SEWAGE DISPOSAL SYSTEM

DEPARTMENT OF HEALTH AND MENTAL HYGIENE

A 58471-E

SUBDIVISION The Woods at Rover Mill II LOT 3 ROAD 13787 Rover Mill Road

Approved Septic System Plan
Howard County Health Department

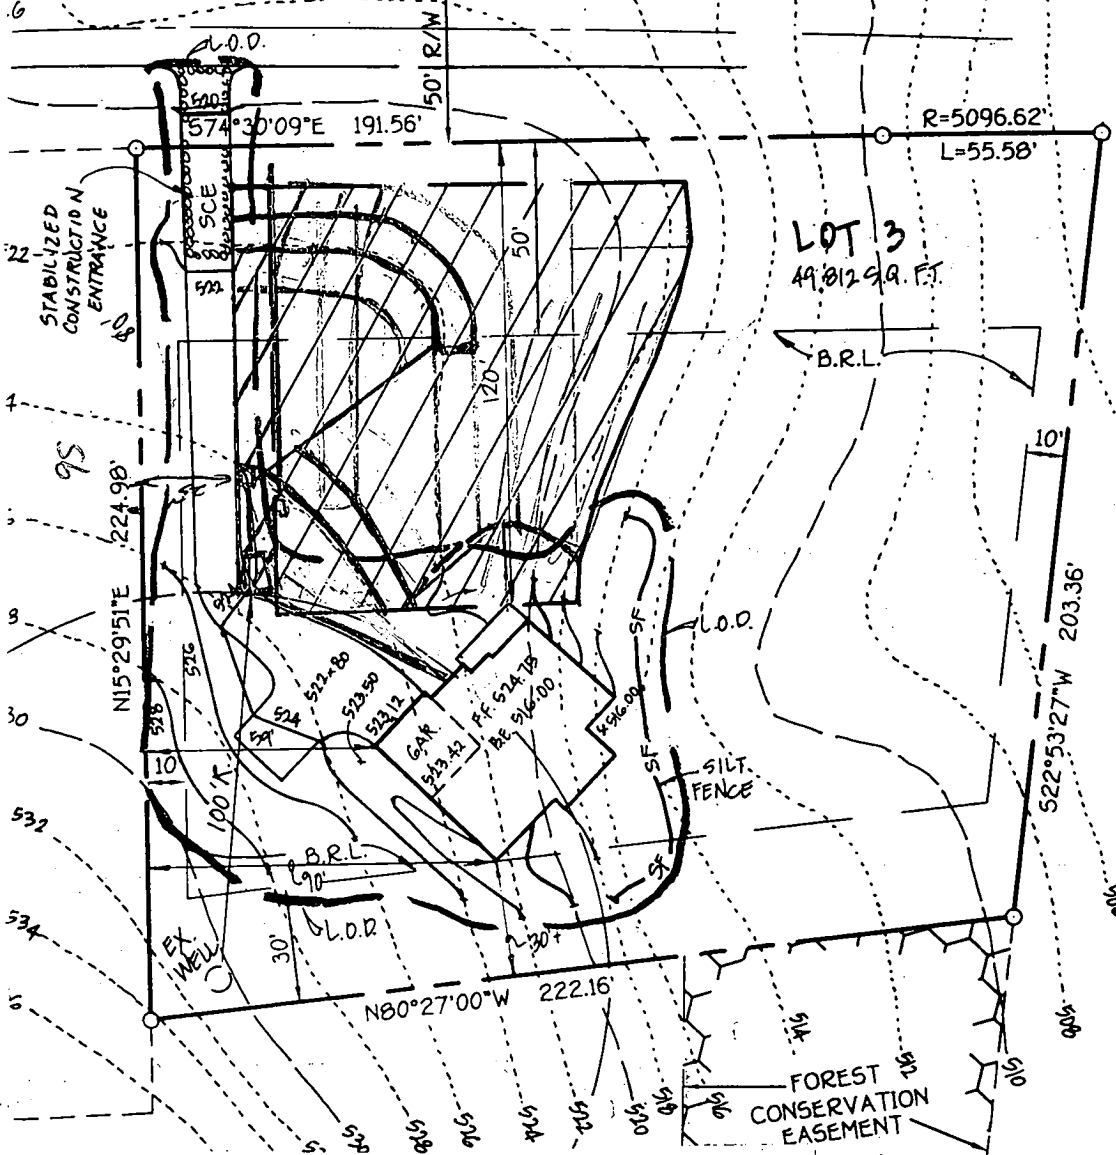
By copy of this plan the Health Dept. accepts this modification to the recorded sewage disposal easement.

HOUSE LOCATION
TOTAL P.02

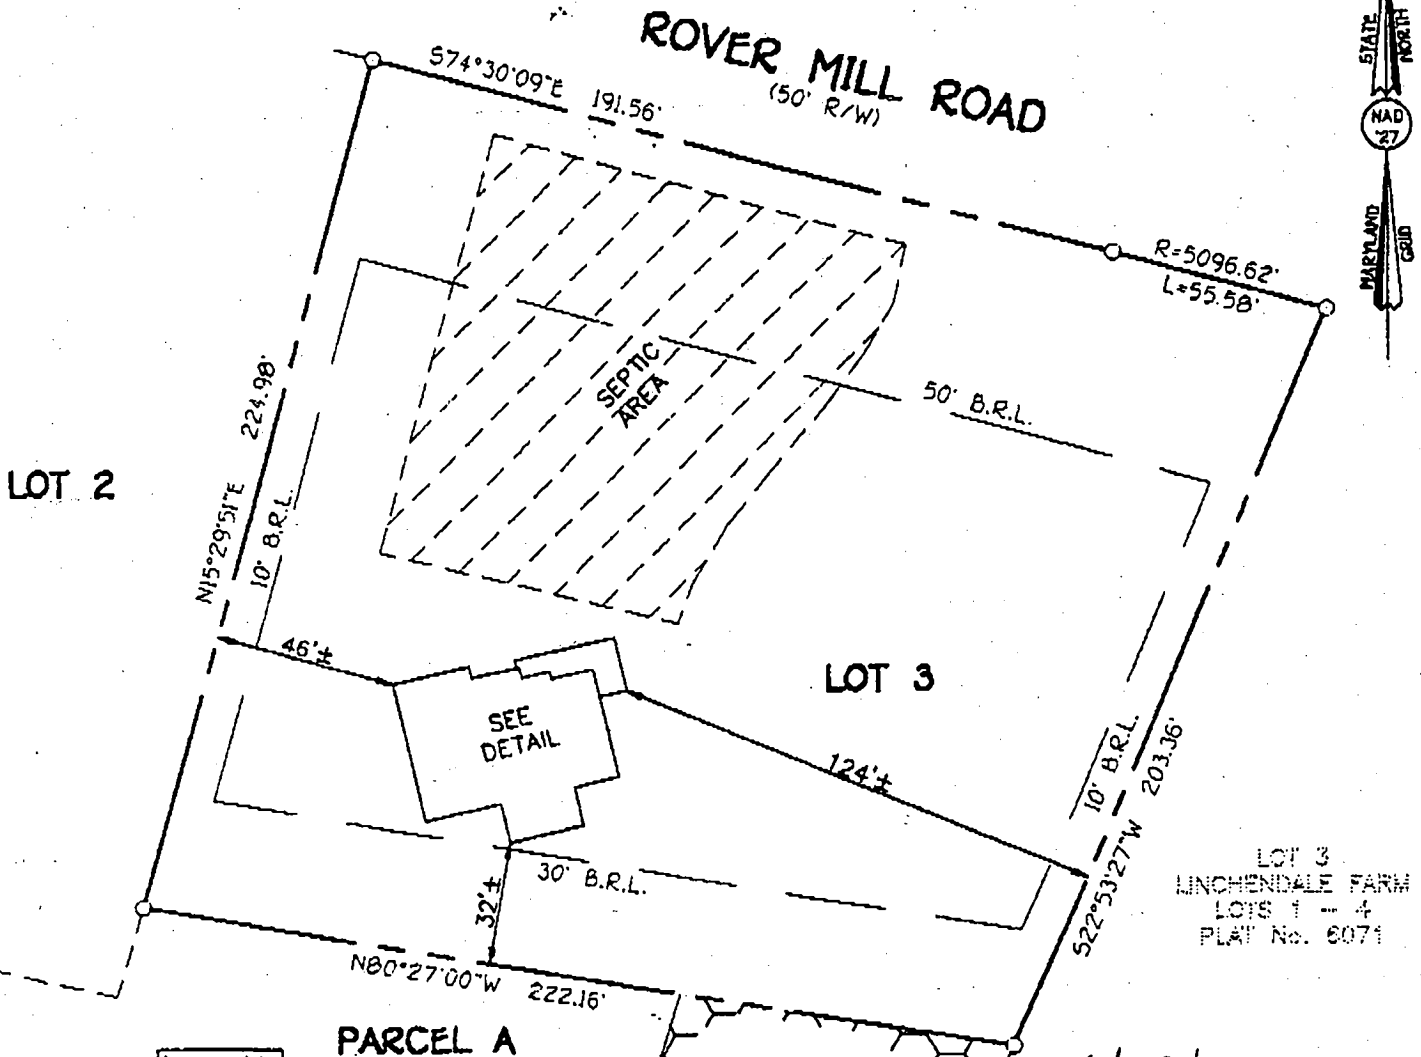
6/29/99
House shifted slightly further from septic area.
OK to proceed
(JCS)
